## Cheikin info

joey\_questions\_2023\_06\_07

10) Bench shape, master bath

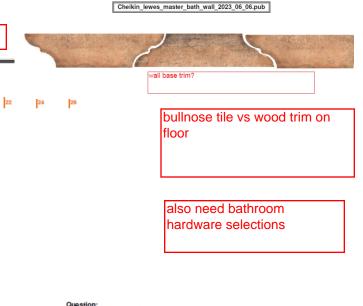
Bench in Corner
